**REMARKS**

**Specification**

Enclosed are nine (9) Annotated Drawing Sheets, wherein various corrections have been denoted in red ink or red highlighting. Also enclosed are thirteen (13) drawing Replacement Sheets.

Figure 5

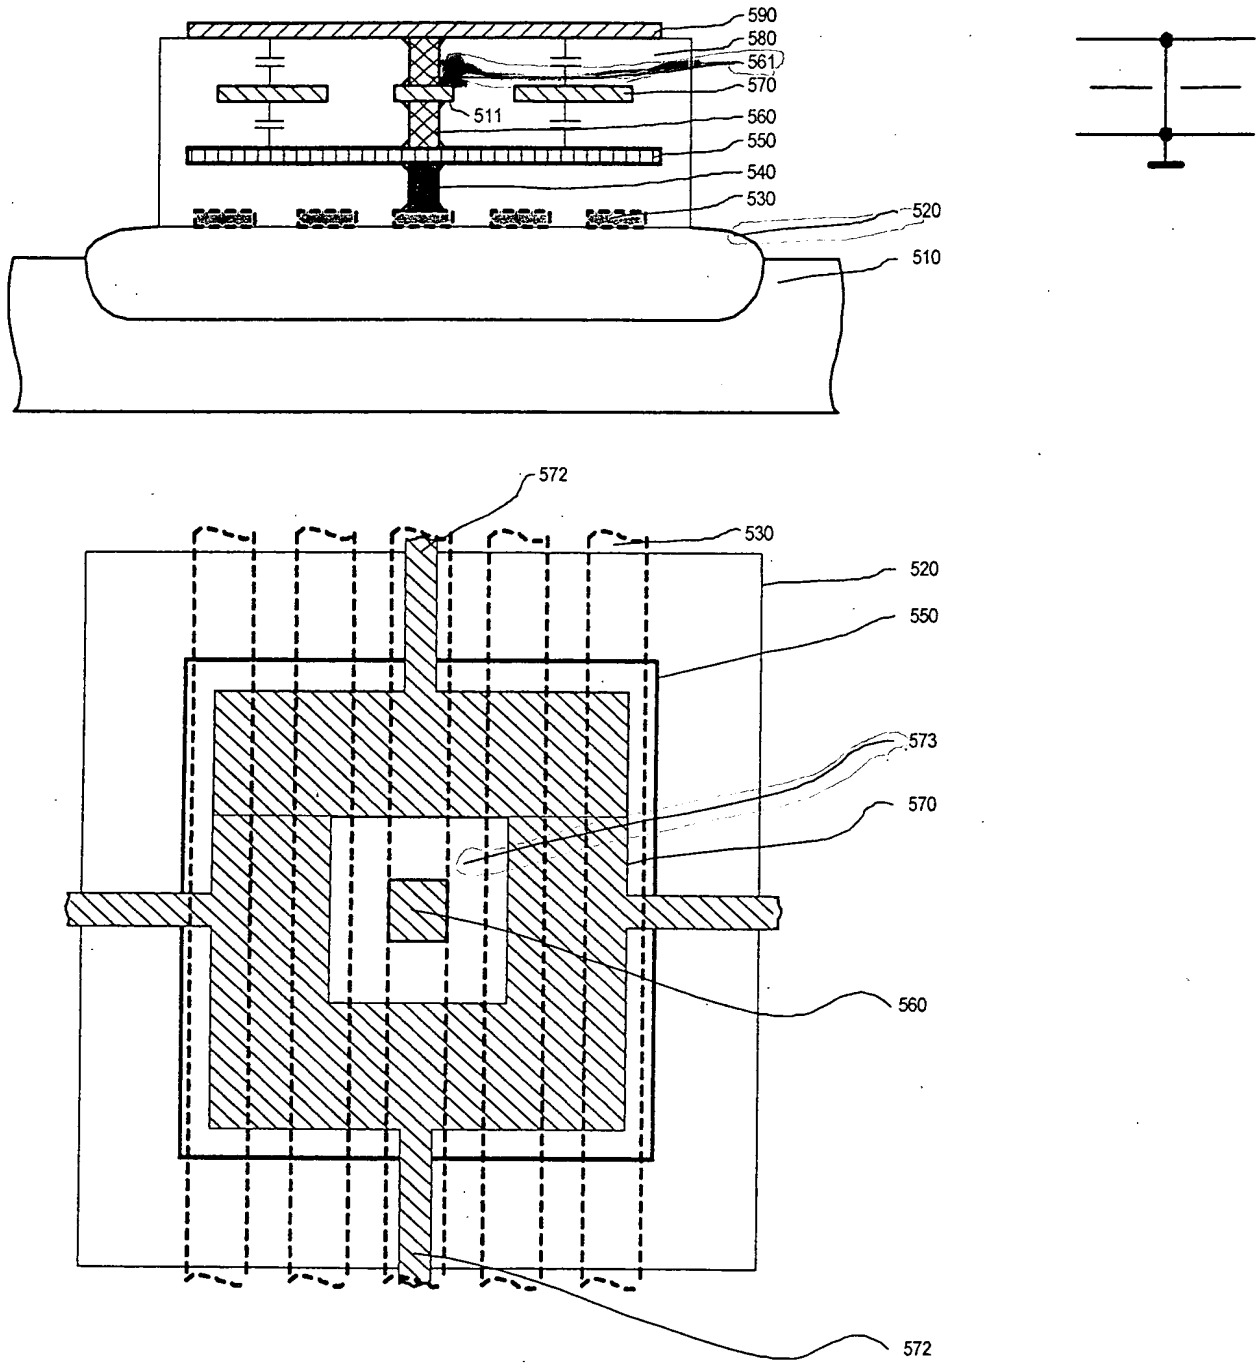
The drawings and specification have been variously corrected in view of the issues raised by the Examiner. For example, page 7 of the specification has been corrected to describe Metal2 plate 511 as illustrated in Fig. 5. Also, via 561 has been denoted in Fig. 5. In Fig. 8, "T1" and "T4" have been clearly denoted. In Fig. 10, "F" has been clearly denoted. Moreover, the various interconnections, lead lines and connections have been made more clear in the figures.

The Examiner has asserted that the bottom conductive pattern of claims 20, 23, 31 and 34 is not clearly described in the specification with respect to the figures. However, Applicants respectfully submit that the bottom conductive pattern 530 as shown in Fig. 5 for example, is described on page 7, lines 4-6 and page 8, lines 3-6. Also, the bottom conductive patterns as illustrated in Figs. 6a – 6d are described on page 8. Applicants therefore respectfully submit that the bottom conductive patterns are clearly described in the specification with respect to the figures, and that claims 20, 23, 31 and 34 are in compliance with 35 U.S.C. 112, first paragraph.
